## County of Hawaii

### PLANNING DEPARTMENT

**PLANNED UNIT DEVELOPMENT PERMIT NO. 06-000001 (PUD 06-000001)**

**Project:** "Redwater Park" – a 10-lot single family residential subdivision

Figure 8: Street Character

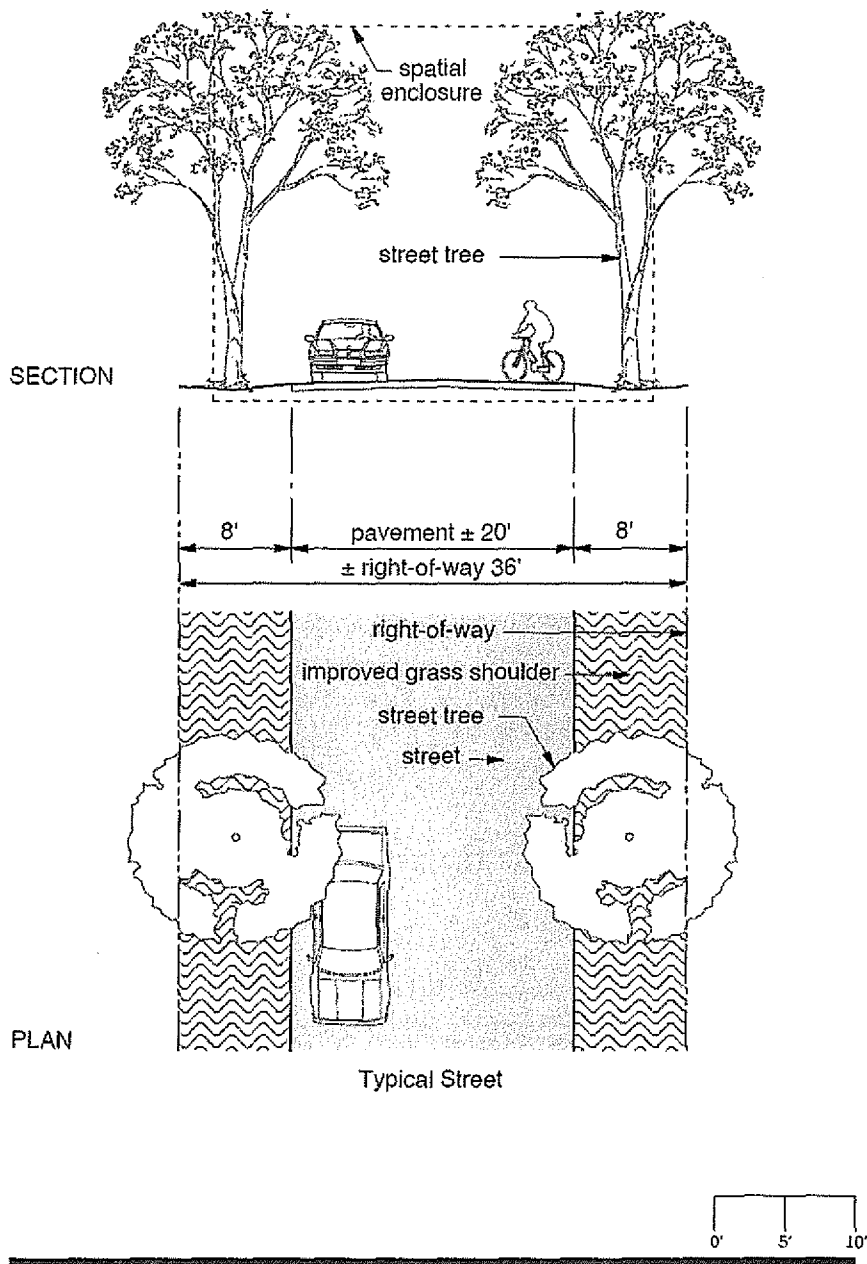
- **Minor Entry Street from Pomaika'i Place (36-foot wide road ROW in lieu of 50-foot wide ROW with alternative shoulder improvements-Figure 8)**. The proposed standards for the 36-foot wide minor street-type roadway will deviate from the minimum 50-foot wide ROW specified by DPW Standard Details R-33 and R-34. The Applicant is proposing a standard pavement width of 20 feet with 8-foot wide grassed stabilized shoulders. The lower volume and speed of vehicles typically carried by this dead-end

minor street affords the opportunity to reduce the pavement width and manage speeds. The proposed 20-foot wide pavement, which does meet County standards, will provide opportunities for a landscaped shoulder/drainage swale while still accommodating two-way traffic.

## Exhibit 2: Yard Designation

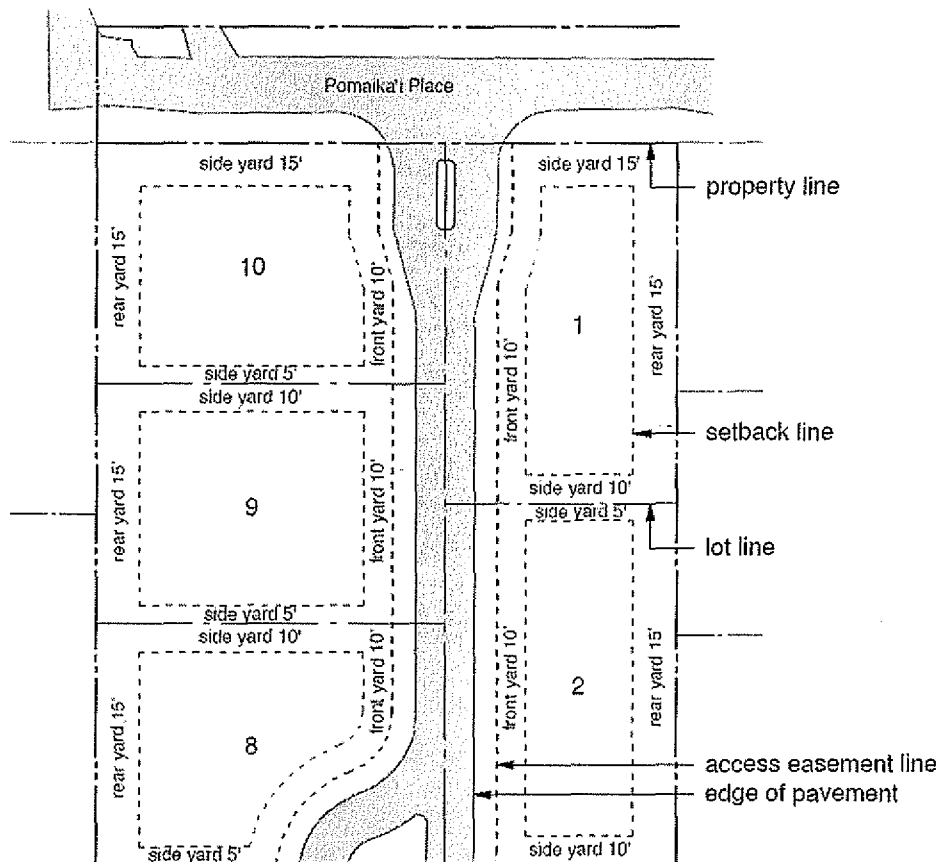
- **General Requirements for Yards and Open Spaces** (Hawaii County Code §25-4-40 & §25-5-7). Applicant is requesting flexibility in the designation of yards, as detailed within Exhibits 2 and 3. The orientation and configuration of the proposed lots and the designation of yards and its setbacks are managed through the master plan to ensure the preservation of reasonable building separation and clearspace. Applicant is requesting a front yard setback of 10 feet and rear yard of 15 feet in lieu of the required 15 feet. Side yard setbacks will range from 5 feet to 10 feet in lieu of the required 8 feet, but assigned in consistent manner so that a minimum combined setback of at least 15 feet between buildings on separate lots will be maintained. The designation of the respective yards is determined by the various exhibits. Note that the front yard setbacks will be taken from the edge of the roadway easement.

- **Corner Building Sites** (Hawaii County Code §25-4-42). While relief from this requirement was not requested, it was implied in the exhibits since side yards are identified along property boundaries we would normally consider as a front yard. We do not have an objection to the

granting of this variance under the condition that the application of yards and setbacks, as approved by this PUD, is limited to the configurations shown on Exhibits 2 and 3.

### Exhibit 4: Fences and Accessory Structures Variance Request - Zoning Code

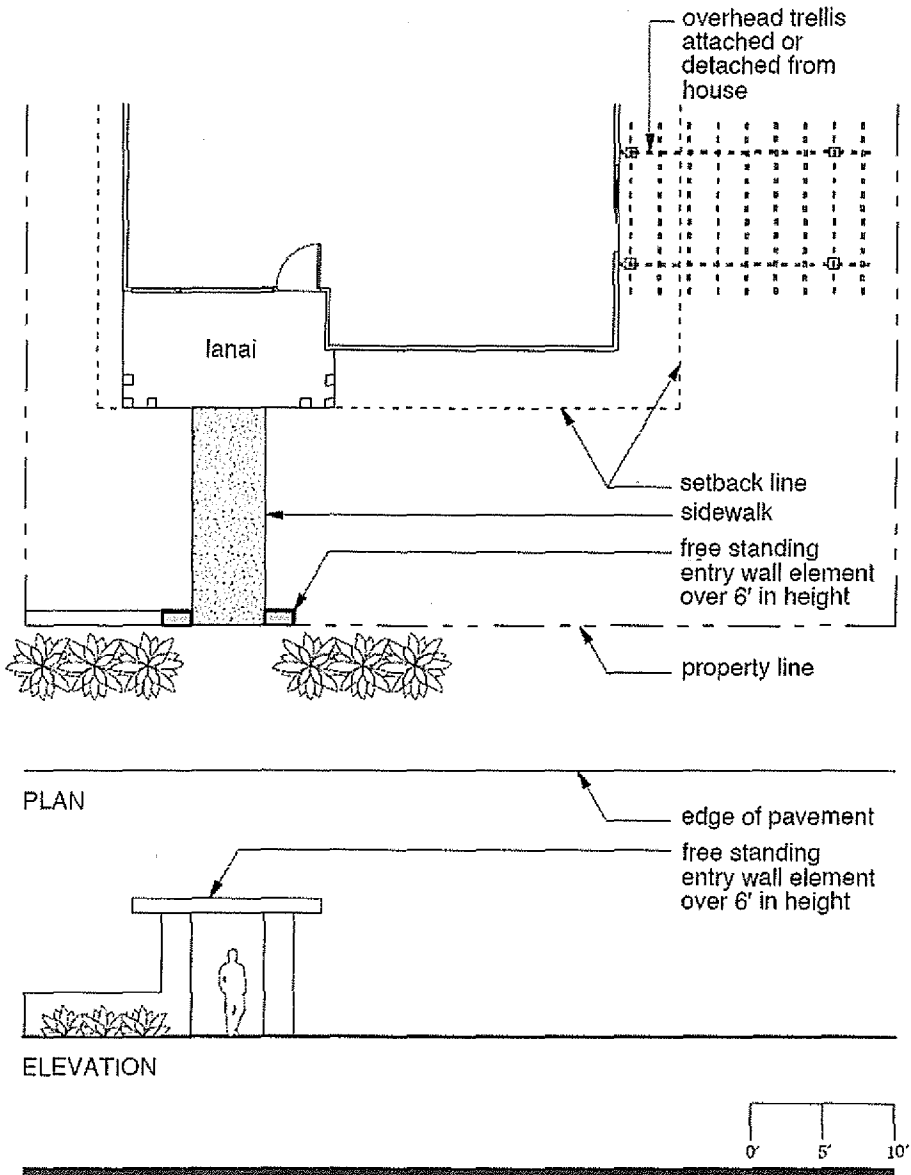
- **Fences and Accessory Structures** (Hawaii County Code §25-4-43). Applicant incorrectly makes reference to retaining walls being limited to 6 feet in height. Maximum height of fences and walls are applied to boundary walls, not retaining walls. The Applicant also wishes to allow for free-standing entry wall features over 6 feet in height into the minimum front yard setback. We have no objection to this requirement, provided it is limited to free-standing entry wall features only as depicted on Exhibit 4 and will not apply to accessory structures, boundary walls or fences.

### Exhibit 6: Street Intersection Angles and Radius Variance Request - Subdivision Control Code

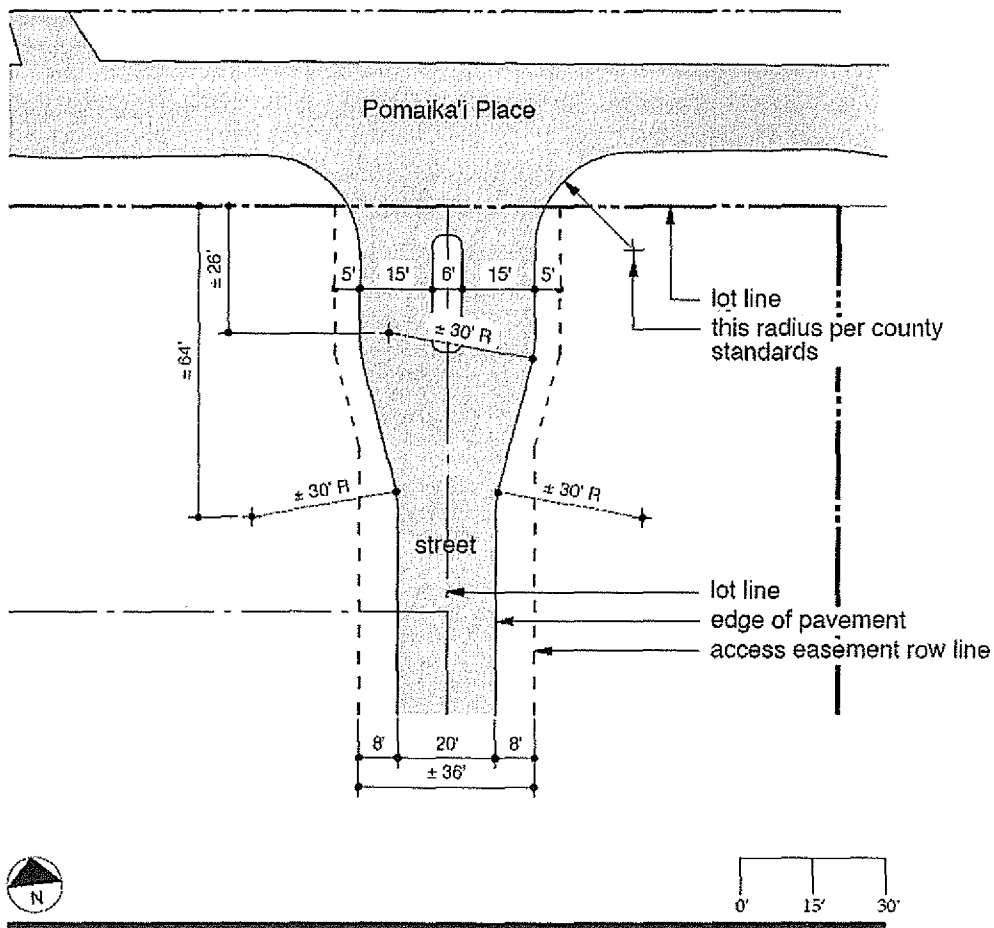
- **Landscaped Median (46 to 65-foot wide roadway easement with 15-foot wide separated travel lanes and 8-foot wide grassed shoulders-Exhibits 6 & 7)**. We approve of the Applicant's request to install a 6 to 22-foot wide landscaped median along the subdivision entry street with 15-foot wide separated travel lanes and 8-foot wide grassed shoulders within a right-of-way ranging between 46 and 65 feet in width. The location of the median must meet with the approval of the Department of Public Works to ensure that its location does not inhibit larger vehicles like buses or fire trucks.

- **Intersection Angles/Corner radius** (Hawaii County Code §23-45(b)). The Applicant's exhibits reflect that the only proposed street intersection with Pomaika'i Place will maintain a minimum radius of 25 feet. Without sufficient justification or evidence that relief is necessary, we deny this variance request.

### Exhibit 10: Street Signs

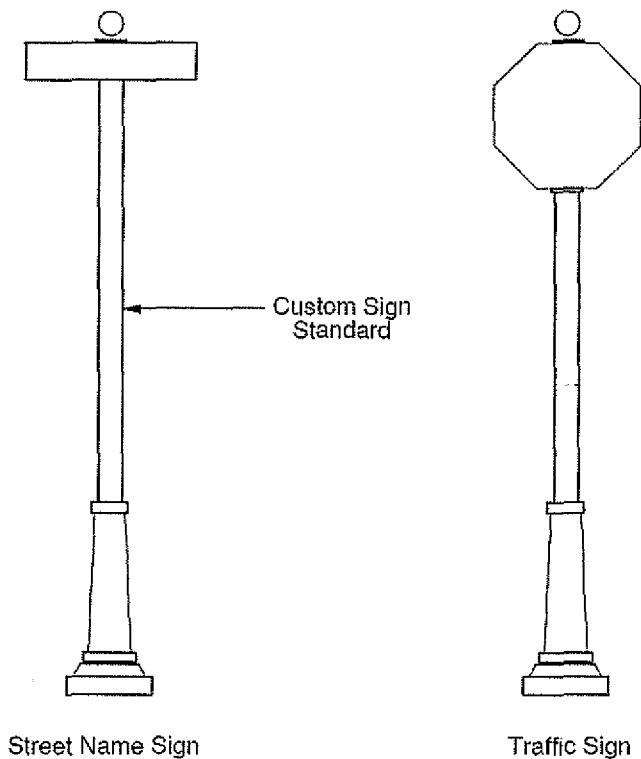
- **Street names & traffic signs** (Hawaii County Code §23-94). Approved to allow use of custom street name and traffic signs that will reinforce the desired character of the neighborhood and its design goals. While this variance will allow these signs to deviate from standard specifications, it must still meet AASHTO specifications.
- **Right of way Improvement** (Hawaii County Code §23-95). While this variance approval would allow for deviation from the County's standard detail regarding the improvement of the entire road right-of-way, such improvements of the right-of-way will be in conformance with the improved right-of-way detail for the approved PUD roadway as shown on Figure 11.
